PROJECT: Rivera Shopping Center

CITY OF LAS VEGAS		DATE:
INTER-OFFICE MEMORANDUM		December 2, 2019
TO: Land Development Services Department of Building & Safety		FROM: Jennifer Shinn, P.E.  Flood Control, Engr. Associate Department of Public Works
SUBJECT:	Drainage Study for:	
	Rivera Shopping Center	
Cross Streets:	Owens Ave and Lamb Blvd	Jesus Rivera
File Number:	F:\Depot\DSMemos\DS5215A.doc	Bart Anderson, P.E., DevCo
Parcel Number:	140-19-803-006	CCPW
Zoning Action:	N/A	
FEMA Flood Zone	YES	NO X
Proposed Storm Drain	YES X	NO

Drainage Study Approval Letter

Subject: Technical Drainage Study for Rivera Shopping Center
Location: NW of Owens Avenue and Lamb Boulevard
APN: 140-19-803-006
Sec, Township, Range: S19, T20S, R62E
Flood Zone & Panel: Shaded Zone X, 2179F, Dated November 16, 2011
Application Number: pw19-12009

FIGURE 5

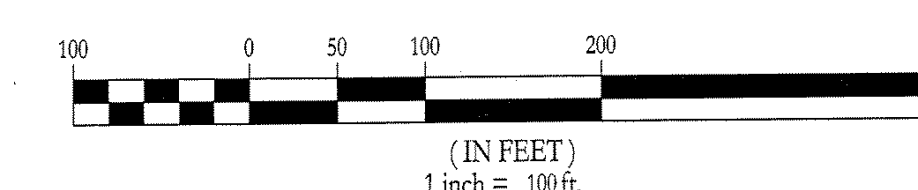
Comment 5: The offsite basin map, Figure 5, must include topography to verify slopes entered in the Standard Form 4 for offsite basins.

Response 5: Figure 5 has been revised to show 1 foot contours onsite and 5 foot contours offsite (See Appendix B). A new HEC-1 analysis has also been provided to show the correct slope for existing basin EOFF1 (See Appendix C).
